From: Jones, William V., EMNRD
Sent: Monday, February 12, 2007 12:39 PM
To: 'clarson@energen.com'
Cc: Ezeanyim, Richard, EMNRD; Sanchez, Daniel J., EMNRD
Subject: SWD Application: State E #1

State "E" #1 SWD

660' FNL and 660' FEL
Sec 3, T-15-S, R-33-E
Lea, Co. NM
Saunders San Andres Field
San Andres SWD Procedure

RE: SWD Application - State "E" #1 SWD
API # 30-025-01216

State "E" #1 SWD

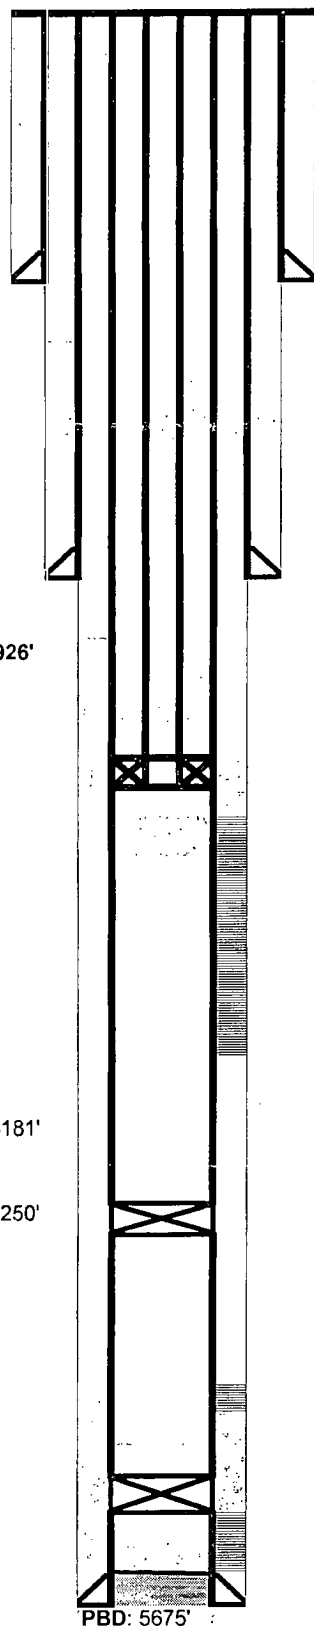
5) Send an "after conversion" wellbore diagram to Santa Fe.

State "F" Well #6
Saunders Permo Upper Penn
Lea County, New Mexico

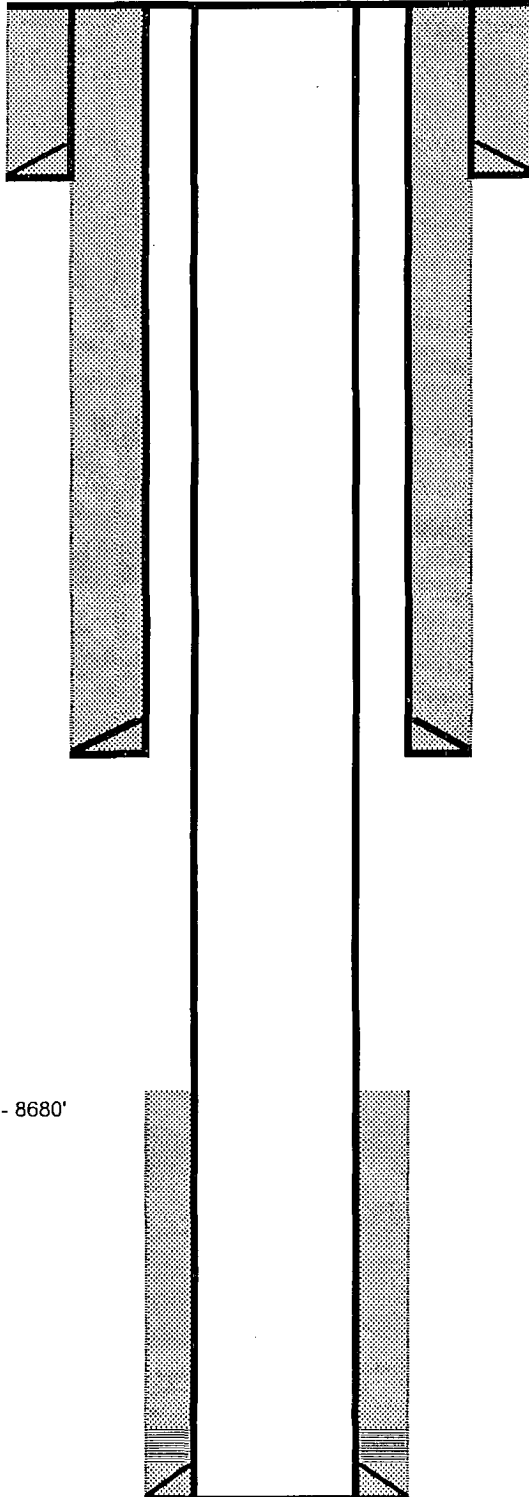
State F #6 30-025-29307 (needs cement from 8600 to at least 4200 feet)

As an alternative to cementing, I respectfully request that ERC be allowed to monitor the bradenhead pressures on these active wells. ERC personnel check the wells daily. Injection would be ceased with any bradenhead pressure change noted, just as ERC would cease injection if the annulus between the tubing and production string were to pressure up. At which point, cement remediation would be performed on the culprit well. Economics of the project do not support the remediation of all three wells. Surface and intermediate casing in these wells are protecting the fresh water zones. Under the current OCD rules for producing wells without cement, the OCD would request remediation if bradenhead pressure were detected. Therefore ERC believes that this request is reasonable.

**Energen will monitor bradenhead pressure on State F #6 for pressure changes.
